Attachment 3 - PLN180611 - 4A 1 Bik Lane, Fitzroy North - Sketch Plans - 17 May 2019

**To:** Gary O'Reilly  
**From:** Artemis Bacani  
**Date:** 8 March 2019  
**Subject:** Application No: PLN18/0644  
 Description: Five-Storey Building – Residential  
 Site Address: 4A/1 Bik Lane, Fitzroy North

TO: Gary O'Reilly (Statutory Planning)  
FROM: Hayley McNicol (Urban Design)  
DATE: 19 February 2019  
SUBJECT: 4A/1 Bik Lane, Fitzroy North  
APPLICATION NO: PLN18/0644  
DESCRIPTION: Development of the land for the construction of three additional storeys to an existing two storey building (5 storeys in total), containing 4 dwellings and a reduction in the car parking requirements.

SECTION AA SHOWING MAX SHADOW

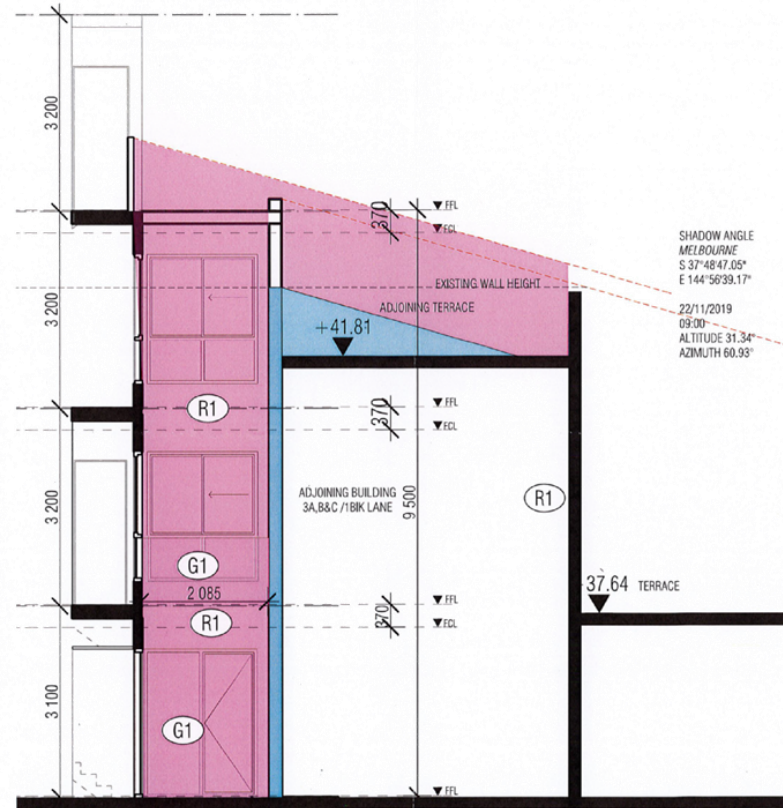
The open courtyard for 4B/1 Bik lane is flush with the first floor level of 4B/1 Bik Lane at RL39.17 . In the current existing condition the courtyard abuts a 5 meter party wall. Please Refer to drawings attached. In the section we have shown the **worst** case scenario for clarity.

SECTION BB SHOWING MAX SHADOW

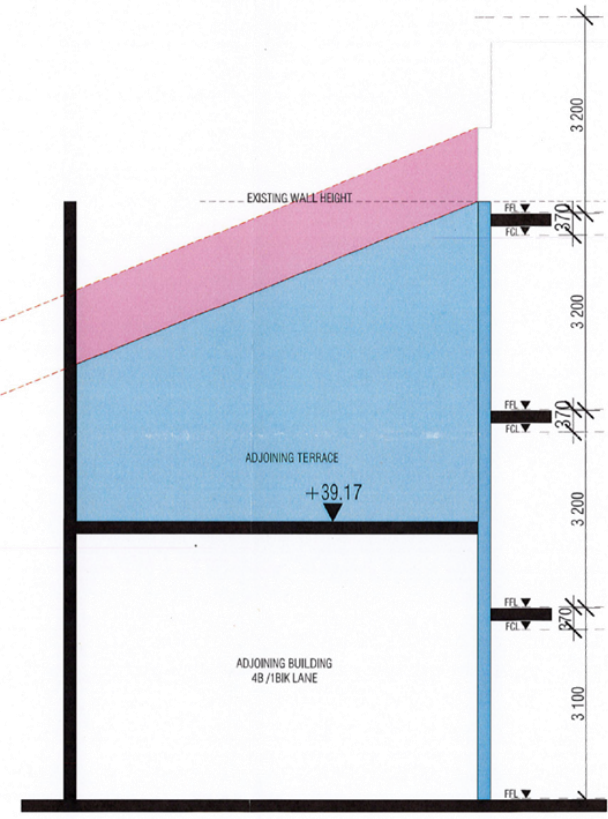
The larger courtyard for 3C/1 Bik lane is higher than the first floor level of 3C/1 Bik Lane at RL41.81 which is still lower than the existing party wall. Please refer to section for worst case scenario.
